**PB# 86-82**

**Benedict Pond Estates**

5/70/87  
Benedict Pond Estates 86-82  
Subdivision (14 lots)

TOWN OF NEW WINDSOR  
PLANNING BOARD  
REVIEW COMMENTS

OPEN DITCH RUNOFF CAPACITYTYPICAL DITCH SECTIONMANNING'S OPEN CHANNEL FLOW CAPACITY

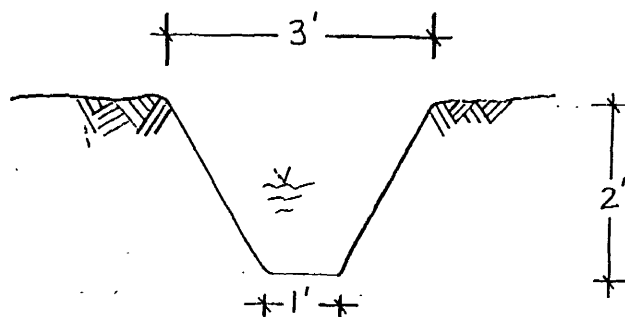
Mr. Walczak: This is Dean Hill Road which goes down a hill and it drains in this direction. These all drain across the street and what I did since I knew it was a concern of the Board, I prepared I know you reviewed the drainage calculations and came out to 10.1 cubic feet per second that would come off of this site during a storm. Without the development, we calculated about 7 cubic feet per second of flow because of the development, it will produce about ten cubic feet per second. So, what I did, I calculated I drew up a typical open ditch which I'd like to show you with the calculations on it to show you that a ditch that is three feet wide at the top, one foot wide at the bottom and about two feet deep will in fact using the formula--

Mr. Walczak: Just let me finish. It will handle 24 cubic feet per second. Now, these are this ditch section is typical of what we anticipate to have out there when the subdivision is completed. In otherwords, the ditches are going to be cleaned to that cross section, the pipes that go across Mount Airy Road will be cleaned out, whatever debris is inside they will be cleaned out so going through all the engineering calculations for the drainage, there is no question that it will work because in fact it will be two and a half times capacity that is required based on our calculations. Mark, you reviewed these calculations and you feel they are reasonable?

Mr. Scheible: Let me ask one question. We all know that these drains were cleaned out over the years when the drain was put in it was cleaned out. We all know it is not too clean today and you are on the side of a hill and just simply, from the brush and grass that keeps on washing down is it possible that along that line there, right along Mount Airy Road when you dig it out and make your swale?

Mr. Pagano: The calculations don't give that figure, the efficiency. So, I have all these figures going out the window as soon as we ask the water go to 90 degrees. I disagree with the engineer. He is agreeing that it will flow in a straight line but I don't see any figures to show me it is going to make a 90 degree turn.

Mr. Edsall: Anything without maintenance will not work so we are assuming there will be maintenance provided by the Town to maintain the drainage. I think Carl the answer is the improvements they are going to make is going to compensate for the additional drainage and Mr. Walczak has submitted to the town calculations that demonstrate that it will help out tremendously.

Mr. Edsall: There is three to one factor between the capacity and the flow so what I am saying is that an again I take no opposition to the Board adding to the requirements to make the system better. If you want to have the system better, fine. What I am saying is that they have given us calculations to show us it is not just barely making it. It is making it with substantially over design. If you are aware of a certain condition I think you should address it.

- LOT #1 -  
(WORST CASE SCENARIO)

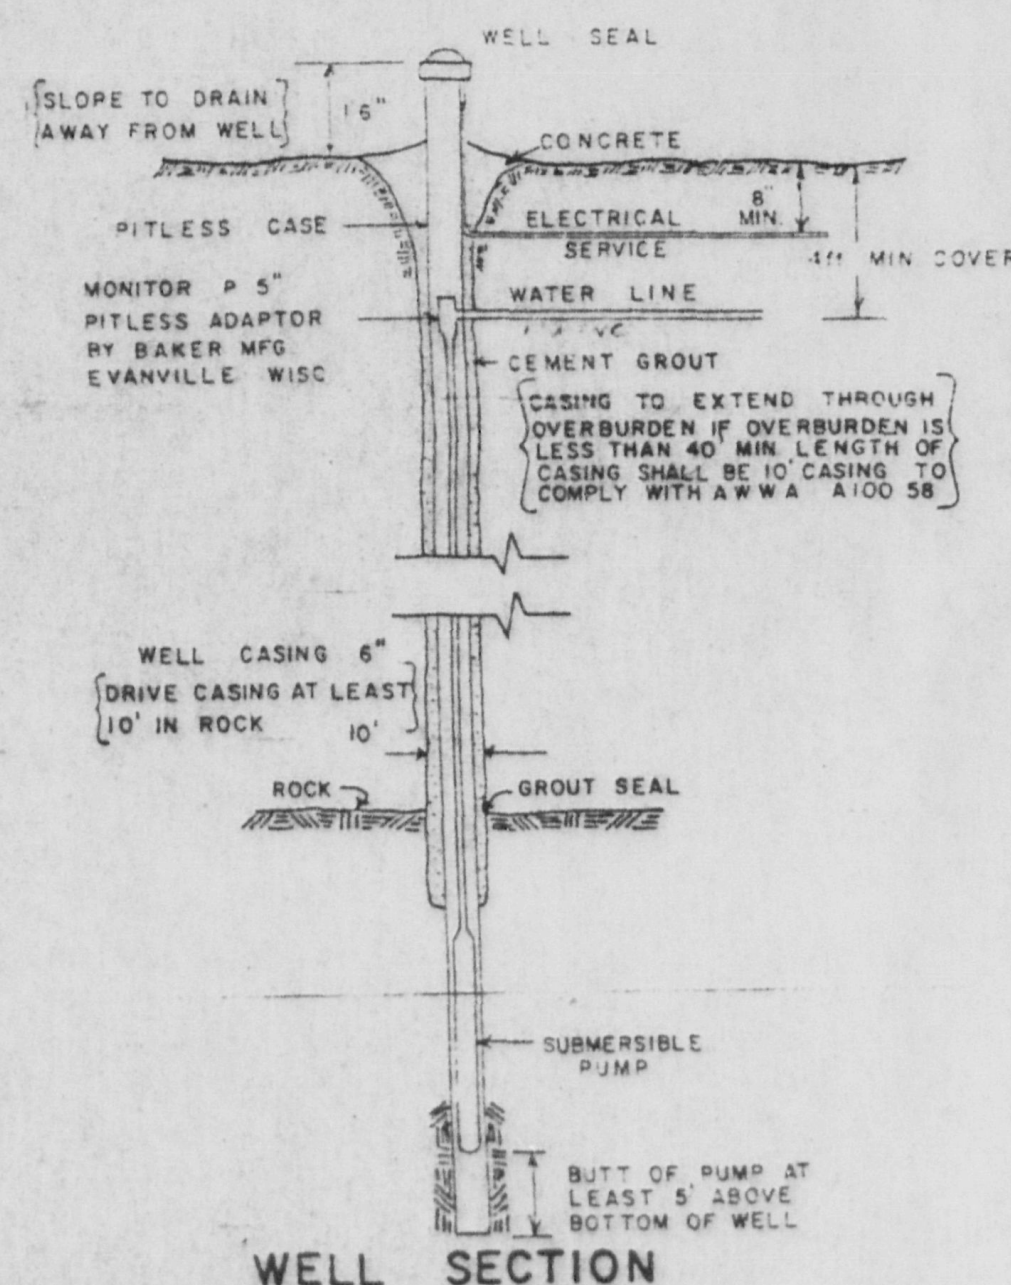
Mr. Edsall: The only comment I have passed on that I am looking for input is the driveways I can explain it somewhat. I had been concerned on previous submittals at the location of the house as shown and assuming that the residents would want their drives to go to the houses a lot of the drives went to 40 percent and 30 and down to a normal percentage in areas if you averaged it it wasn't that we are not looking for a mining operation to grade the whole site we are trying to keep the grades reasonable. Charlie demonstrated by relocating the houses towards the roads the drives could be brought down to 16. What I am looking for from the Board is obviously if you want to restrict the slopes the submittal should show the locations of the houses suitable for the driveways you want. I don't know what kind of drives the Board would prefer. We had some concerns from the superintendent of highways about the visibility on the road so my recommendation is you wouldn't want very steep drives on those roads. That is questionable you may want to restrict so that he can work his submittals based on that.

Mr. Walczak: I drew a sketch of this and submitted it because this is the worse case the greatest drive elevation between the road and house location if the house were located as shown up here we are looking at cross section at the worse case you'd have a 20 percent grade from the road to the house. If the house were located lower on the lot and I picked arbitrary point somewhere here you can see you can get a 16 percent grade off the drive to the house. I disagree with your engineer's comment about 40 percent grade because there is nowhere does there exist a 40 percent grade.

Mr. Mc Carville: I'd like to see the grades indicated on the final plans for the drives if that is not a problem.
